# Conceptual Review Agenda

7-Eleven at Prospect Ridge

CDR240034

# 7-Eleven at Prospect Ridge- Convenience Retail Stores with Fuel

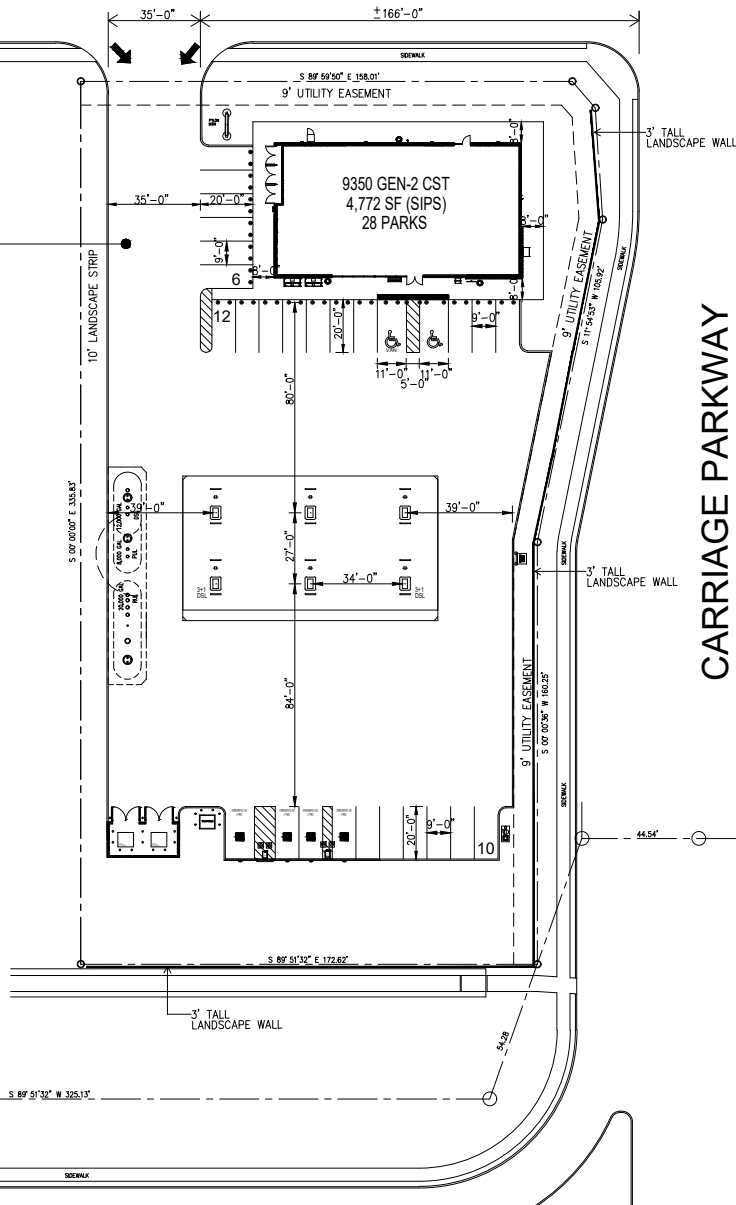
A fundamental community character standard for the City of Fort Collins is for buildings to provide a direct relationship to the adjoining street system without an intervening vehicle use area (parking or drive aisles). In the case of this site the building must be brought to the street corner of Prospect and Carriage Parkway.

The main entrance of the building must face and open directly onto a connecting walkway. A connecting walkway is defined as, "(1) any street sidewalk, or (2) any walkway that directly connects a main entrance of a building to the street sidewalk without requiring pedestrians to walk across parking lots or driveways, around buildings or around parking lot outlines which are not aligned to a logical route." Illustrations of this concept can be found in the Fort Collins Design Manual, <https://www.fcgov.com/planning/pdf/dm-3.5.3.pdf>.

Regarding perimeter landscaping requirements, the plan will be required to provide a landscape setback area of 5 feet and along the western boundary and 10 feet along the north and east boundaries. Within the landscape setback area, screening from either the street or property to the west shall consist of a wall, fence, planter, earthen berm, plant material or a combination of such elements, each of which shall have a minimum height of thirty (30) inches. Such screening shall extend a minimum of seventy (70) percent of the length of the street frontage of the parking lot and also seventy (70) percent of the length of any boundary of the parking lot that abuts any nonresidential use. Openings in the required screening shall be permitted for such features as access ways or drainage ways. Where screening from the street is required, plans submitted for review shall include a graphic depiction of the parking lot screening as seen from the street.

The 50 foot setback area between the building and prospect road will be required to be landscaped in accordance with the 'Gateway Style' of the Prospect Road Streetscape Program (PRSP). Regarding the ditch that will be undergrounded as part of the infrastructure project, the PRSP calls out for the ditch lines to be expressed with a double row of plantings. This might be a good opportunity to give nod to the historic alignment of the ditch and provide visual separation between parking areas of LOT 6 and future development of Lot 7 as required by the Gateway Style Standards. These Standards limit parking areas from extending more than 300 feet along prospect road without a significant visual break provided by landscaping open space or buildings. Please work with environmental planning and city planning staff to discuss this concept in greater detail.

How will cross access between properties be established? This issue should be studied in greater detail with the goal of providing adequate drive spacing to the nearest intersection. Please work with traffic engineering to determine the best approach.
